FEBRUARY
STAFF REPORT

**CONWAY
HISTORIC DISTRICT COMMISSION
MEETING**

1. Tumlinson Residence - Detached Pavilion - 1221 Mitchell Street

OLD CONWAY DESIGN OVERLAY DISTRICT CERTIFICATE OF APPROPRIATENESS REVIEW

Ranch Pavilion

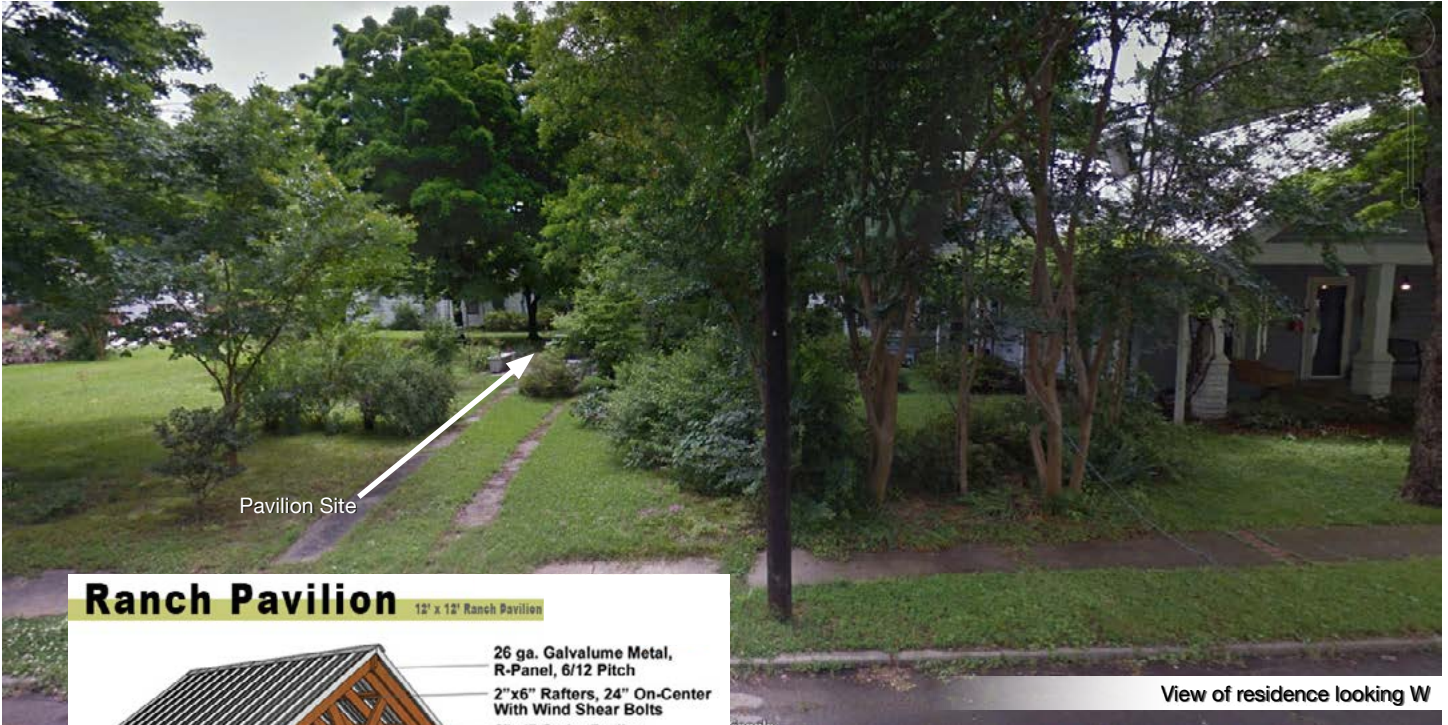
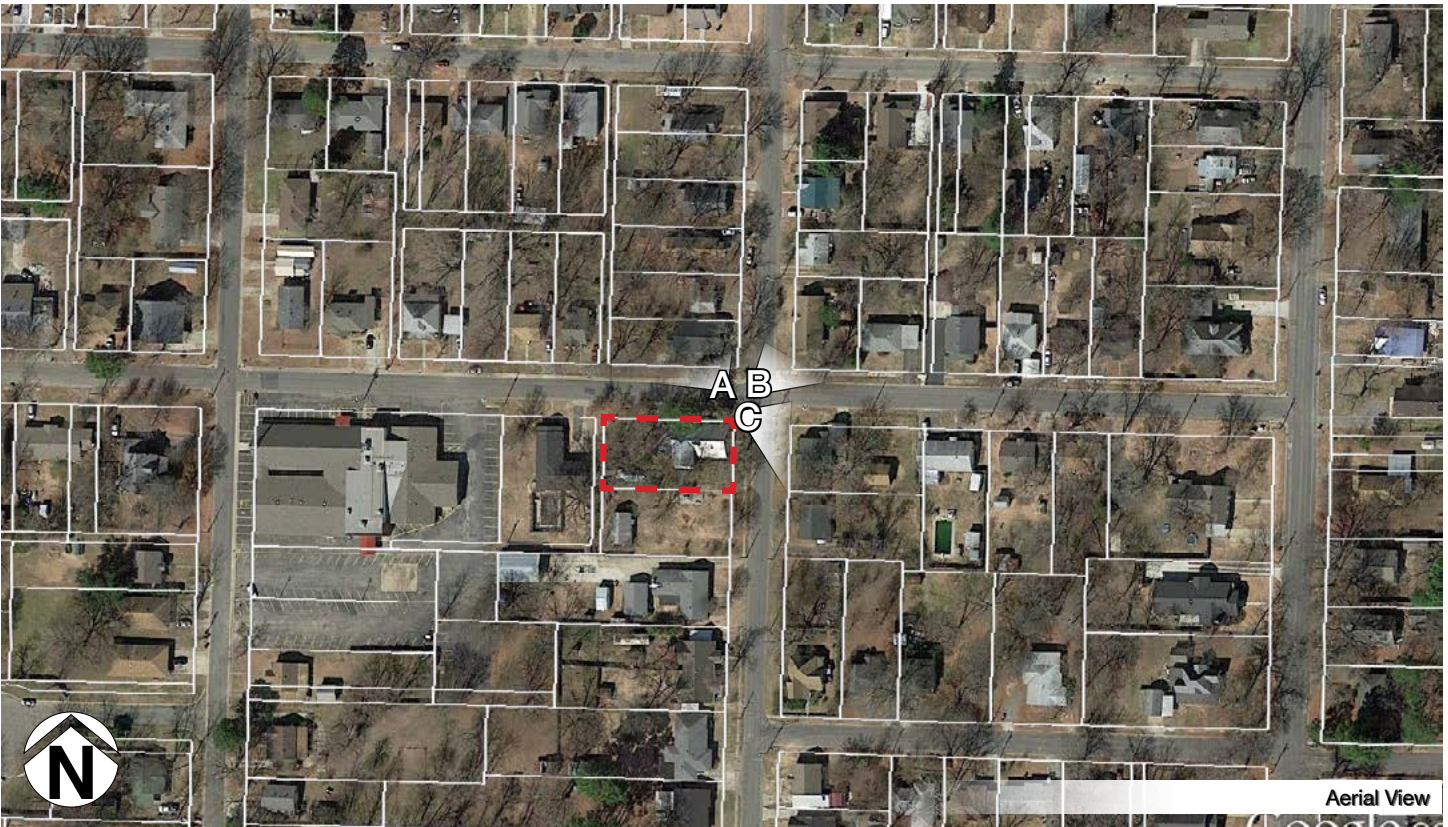
Style: The style should compliment existing and area structures. The pavilion is a post and beam exterior “garden” type structure. It has open rafter tails and will blend the abutting residence.

Roof: The roof is a metal galvalume roof. Although not typical for the Old Conway Area, galvalume is appropriate for a “garden” pavilion. The abutting residence also has a metal roof.

1. The pavilion shall be constructed as submitted
2. Any site lighting shall be inward, downward, and shrouded.
